RE: Appeal of Planning Commission Resolution No. 15-66 for MWest – Jarvis RDCS Application No. MC-15-12, 19.5 acres at Butterfield Boulevard and Jarvis Drive, Morgan Hill, CA

MWEST-JARVIS CONTESTED POINT SCORES IN THE 2015 RDCS COMPETITION

SHEET
A-2.2

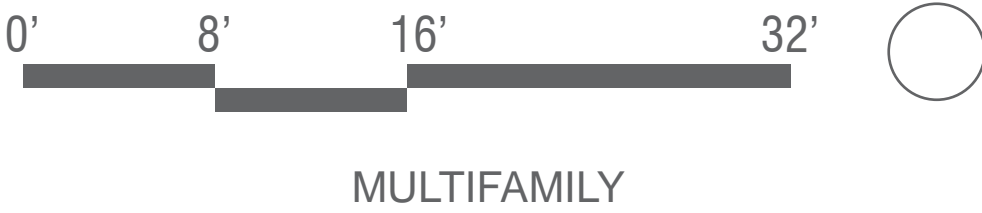
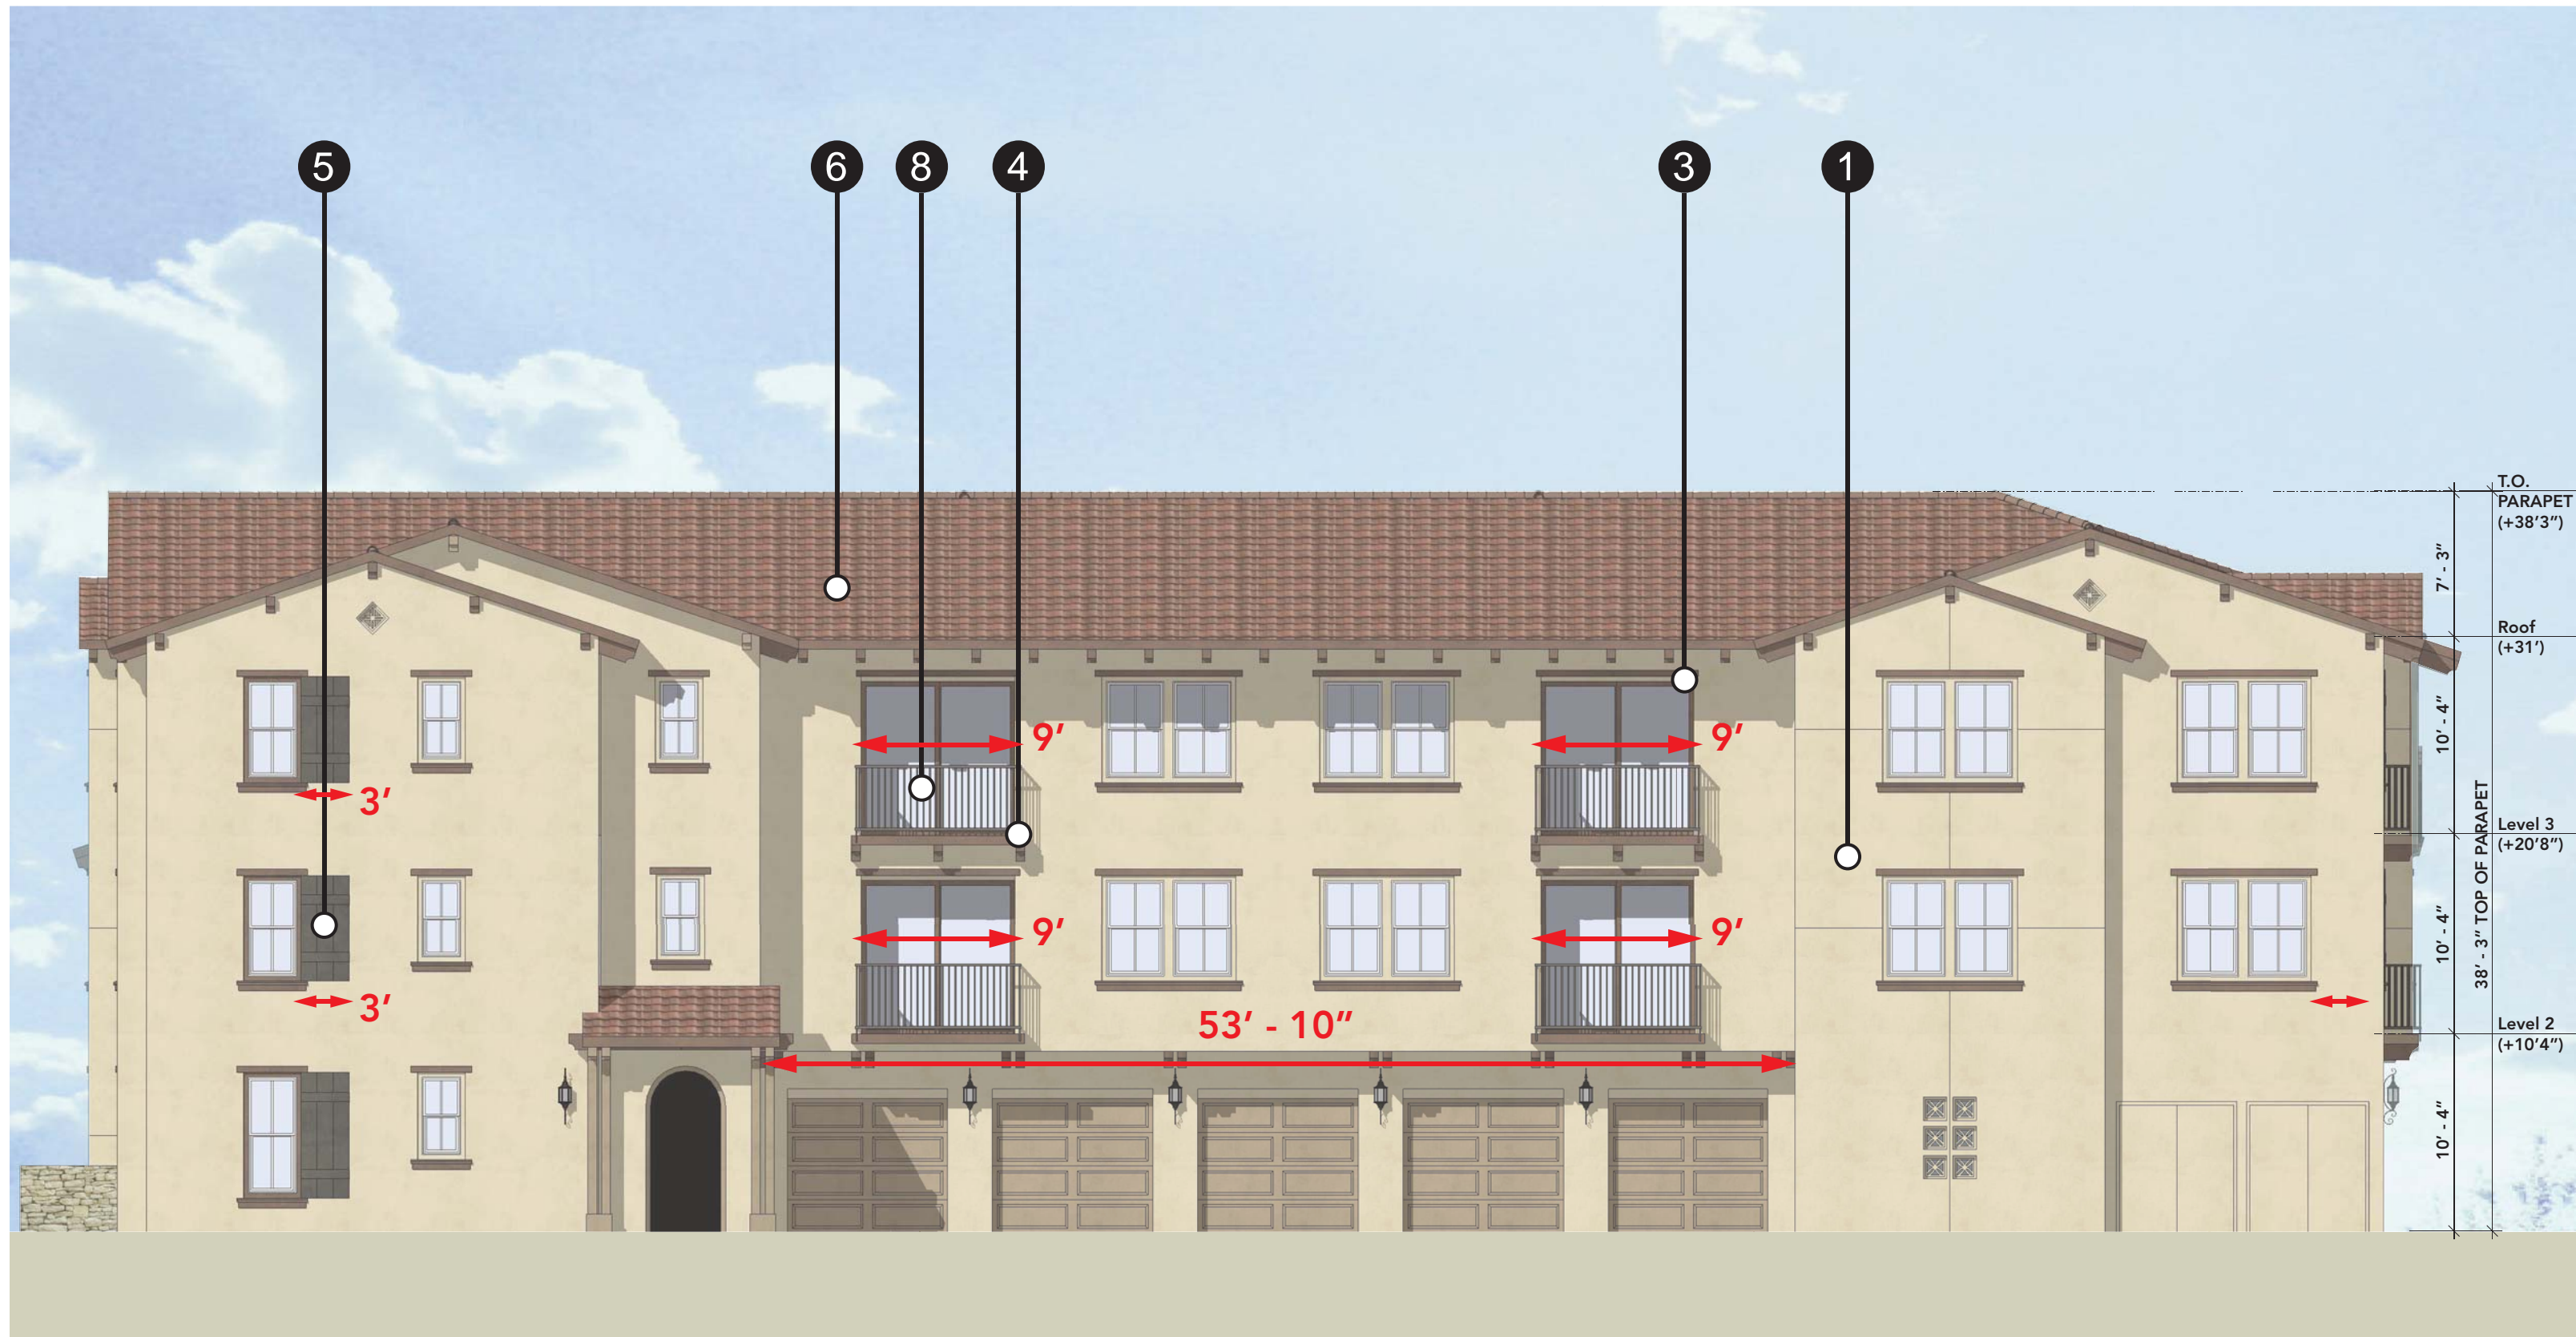
Staff/PC Response: “The massing of structures does not provide a compatible transition with the adjacent neighborhood.”

Applicant Response: In deference to our Jarvis neighbors, we designed a customized building with a combination of 2 and 3 story elements, so that the 2 story façade faces Jarvis. This mirrors the homes in the Madrone Plaza neighborhood, which also appear as 2 story (they are actually 3 story) from the street and step back to 3 stories. In Butterfield Village, our buildings have compatible 2 story edges that drop the building down to a scale that is commonly found in single family neighborhoods. The 3 story

edge, which is only a third of the building facade, steps back more than 8 feet to further distance itself from the street and our Jarvis neighbors. The height of the 3 story portion corresponds to the height of our neighbors due to their split level floor plan, and the length of buildings is comparable. Our building plan also takes into consideration the need to create 4-sided architecture. The plan shape, much like a capital "I" allows for movement along the facade while also tucking parking out of view. This façade movement breaks down scale and creates even more visual interest than what might be seen in a typical row-town type building. (Please see RDCS sheets A-1.2 – A-2.9)
